Engineering Memo

To: **All Stores and Sales Locations**
Date: **October 27, 2020**
Re: **Incorrect License Plate Wiring on Certain Water Trailers – Procedure to Correct**

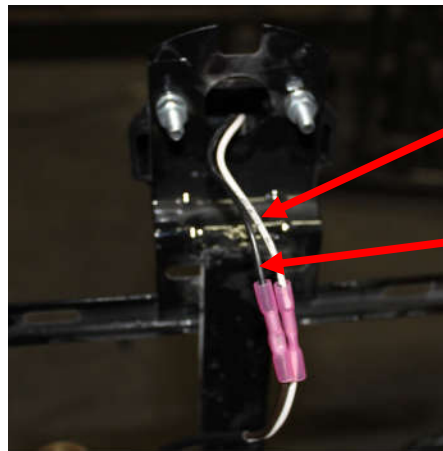
A single-wire license plate light was temporarily used that created confusion at installation. The black wire on the license plate light is attached to the ground wire on the harness. The power wire is attached to ground, creating the potential for a short circuit.

Change out the license plate light. First, cut the black wire from the light, as well as white wire from harness, just adjacent to the splicer connection, and discard splicer. Cut ring end off white wire and discard ring end. Remove the existing silver lamp and discard. Install new black license plate lamp with hardware. Strip insulation as needed from wire ends, and splice brown harness wire to black, and white harness wire to white as shown below.

Above picture on the right applies to **surge brake units only**. **Note:** if you have a unit with electric brakes, ground wire color may be different, and may vary by model. Please test polarity to verify.
